REQUEST

Current Zoning: O-1(CD) (office, conditional)
Proposed Zoning: O-1(CD)SPA (office, conditional, site plan amendment)

Approximately 1.27 acres located on the north side of Ballantyne Commons Parkway, east of Rea Road
(Council District 7 - Driggs)

PLANNING STAFF REVIEW

• Proposed Request Details

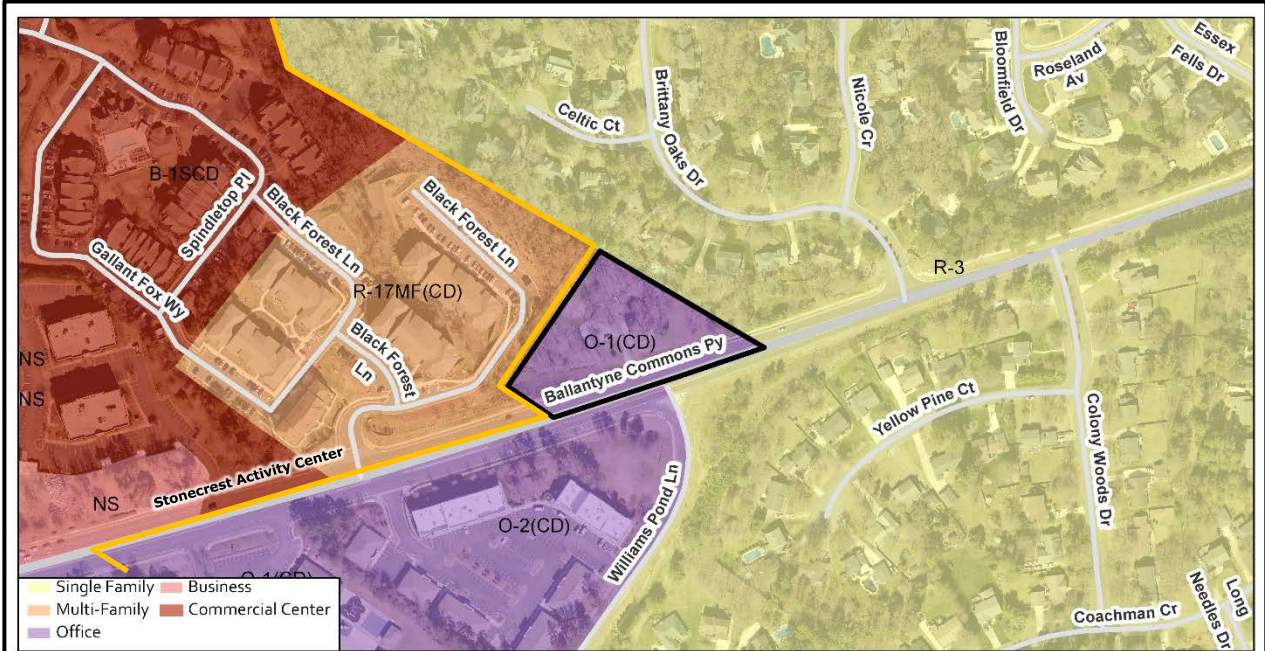
The site plan amendment contains the following changes:

- Allow the demolition of the existing 2,982-square foot structure, a single-family home that was to remain and be used for office through prior rezoning petition 2013-014.

- Proposes the construction of a 24,750-square foot office building with associated over/under parking structure to be built into topography (the upper level of the parking will be at ground level along the northeast side of the site with a second level of parking below ground).

- Provides a 165-foot class C buffer with a ten-foot screen wall along the northeast property line, abutting single family uses. Specifies this buffer will not be reduced. The previous plan required a 16-foot class C buffer that was allowed to be reduced to 12 feet with a fence or wall.

- Provides a Class C buffer along the northwest property line, abutting multi-family uses. This buffer will be reduced as allowed by the Zoning Ordinance.

- Changes the allowed uses from only office uses to office, medical office or financial uses and adds prohibition on accessory drive-through windows.
- Replaces the five-foot wide sidewalk that was previously allowed to remain with an eight-foot planting strip and six-foot sidewalk along the frontage of Ballantyne Commons Parkway.

1. ~~Expand Note 7 under Architectural Guidelines to state that the entry plaza will include pedestrian amenities such as, but not limited to, seating areas, art, water features and/or specialty landscaping.~~ Addressed.

2. ~~Label the storefront entry and clear glass windows on the first floor of the building renderings.~~ Addressed.
3. ~~Amend the buffer and label along the northwest property line to provide a 12-ft wide (16 feet reduced by 25% with the screening fence) Class C buffer, rather than 10 feet as shown on the site plan. In addition, add a note under Streetscape and Landscaping that reads "A 16' Class C buffer along the northwestern property line will be reduced to 12 ft with the provision of a 6' tall screen wall."~~ Addressed.

4. ~~Amend the site plan to show a 16-foot Class C buffer along the northeastern property line rather than a 15-foot buffer. In addition, amend Note 12 to read "The 16' Class C buffer may not be reduced along the northeastern property line. A 6' tall screen wall will be provided along the northeastern property line."~~ Addressed, additionally the petitioner increased the height of the screen wall along the northeast property line to 10 feet.

6. ~~Update the site plan to show two feet of right-of-way behind the sidewalk or show a two-foot easement behind sidewalk.~~ Addressed, the petitioner added an easement two-feet behind the sidewalk.
